SERVICE BULLETIN N° 101-33

ERRATUM

SN CENTRAIR 101 gliders
all "Pegasus" types

SUBJECT: TO ENSURE CORRECT INSTALLATION OF THE AIRBRAKE PLATES ON THE WING.

Sketch No. 1: Airbrake linkage in the wing (shown with the airbrake plates partly extended)

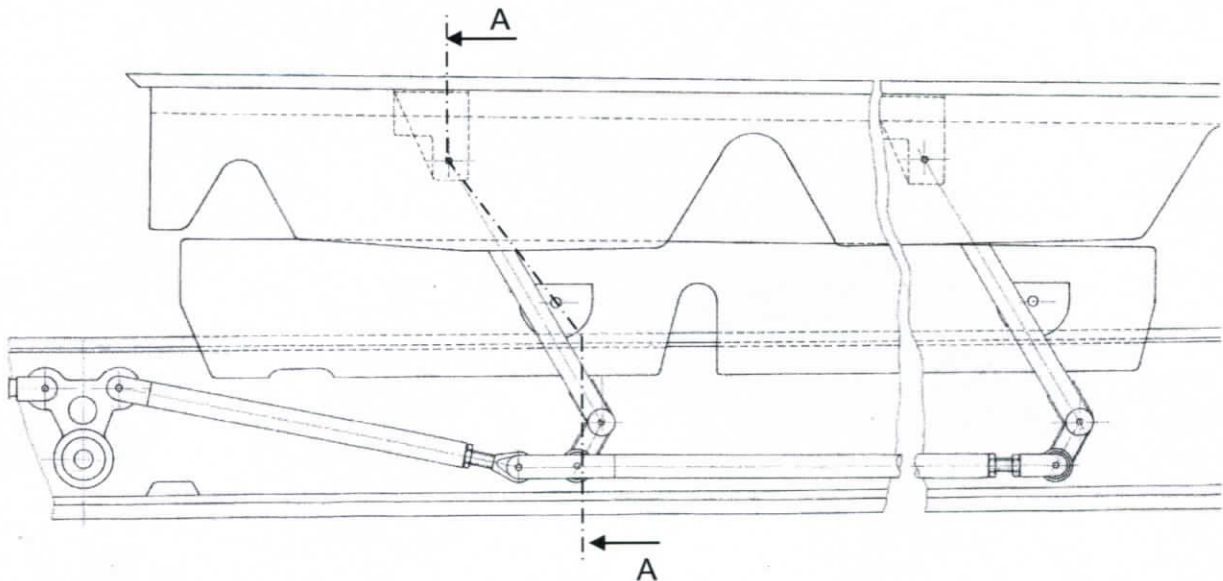
The airbrake plates are mounted on arms hinged from the wing (see sketches Nos. 1 and 2 on the following pages).

Sketch No. 2:
Section AA from
sketch No. 1
(shown with
airbrake
extended)

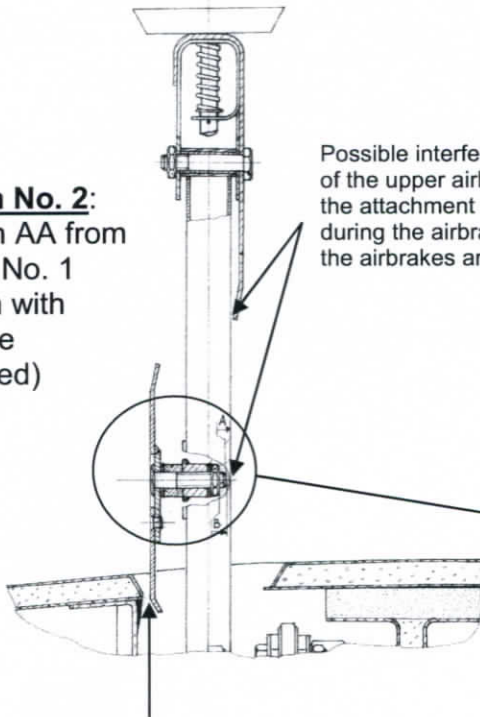
- the structure of the wing and the lower airbrake plate (cf. Sketch No. 2)
- the bottom of the front face of the upper airbrake plate and the ends of the attachment bolts of the lower plate (cf. Sketch No. 2)
- the top of the lower plate and the end of the 2 attachment bolts for the upper plate (cf. Sketch No. 4)

Clearance between the
wing structure and the
lower airbrake plate

Possible interference between the bottom
of the upper airbrake plate and the end of
the attachment bolt of the lower plate
during the airbrake retraction motion (when
the airbrakes are half retracted)

- Point 1: The presence of adequate functional clearance between the lower spoiler airbrake plate and the structure of the wing (see sketch No. 2)
- Point 2: The values of dimension B (see sketch No. 3, protrusion of the bolt relative to the locknut) which should be at least 1.5mm and dimension A which should be more than 0.6mm (risk of interference with the bottom edge of the upper airbrake plate).
- Point 3: The presence of a clearance between the top of the lower airbrake plate and the end of the attachment bolt of the upper airbrake plate (cf. Sketch No. 4)

In the event of inadequate clearance, check the tightening of the 2 attachment nuts of the lower plate (cf. Sketch No. 3) and inspect for any possible distortion of the lower airbrake plate. Correct any defects found.

Sketch No. 3:
Installation detail of the
lower airbrake plate bolt

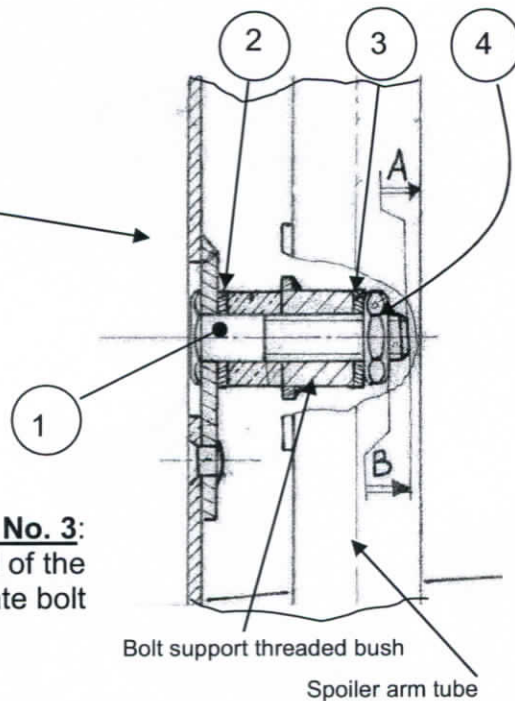
Note: The tightening of bolt, Item 1, must be moderate.
It must not cause excessive friction in the pivoting
motion of the airbrake arms.
It must however be sufficient to ensure proper
guidance of the airbrake plate (it should not be able to
incline relative to the spoiler airbrake arm).
The locknut, Item. 4 (installed with Loctite "Medium
threadlock" ref. 243) is intended to lock bolt, Item 1,
in position.

In the event of non-compliance with these values, the glider must be reconditioned for flight by ensuring compliance of the installation of the bolts for the lower airbrake plates with sketch No. 3.

The total length of the bolts, Item 1 in sketch No. 3, under their heads, must be 26.5mm. If the length of the bolts fitted to the glider is different, they must be replaced with bolts part number SY856A.

Washer, Item 2 (part No. SN CENTRAIR 400126) in sketch No. 3 is optional and is intended to modify the clearance between the lower airbrake plate and the structure of the wing as well as the free length of the bolt behind the locknut, Item No. 4 (see sketch No. 3). It may be deleted if necessary to modify the above clearances.

It may be necessary to slightly chamfer washer No. 3 (part No. SN CENTRAIR 400126) to avoid any possible interference between this washer and the weld of the bolt support threaded bush with the airbrake arm tube

Nut No. 4 must be replaced with a new nut each time it is removed (nut part No. SN CENTRAIR 400030). It must be installed using Loctite "Medium threadlock" ref. 243.

Sketch No. 4: Section AA from sketch No. 1 (shown with the airbrake 2/3 retracted)

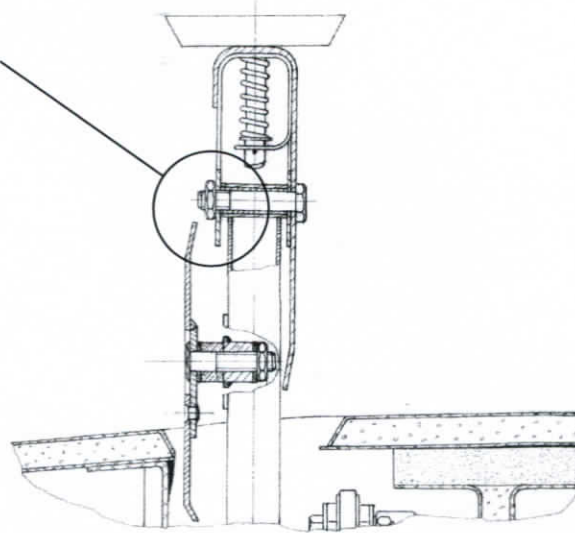
Possible interference between the top of the lower airbrake plate and the end of the attachment bolt of the upper plate during the airbrake retraction motion (when the airbrakes are 2/3 retracted)

Point 3: Concerns Point 3 of Action No. 1

In the event of inadequate clearance, check the tightening of the 2 attachment nuts of the lower plate (cf. Sketch No. 3) and inspect for any possible distortion of the lower airbrake plate. Correct any defects found.
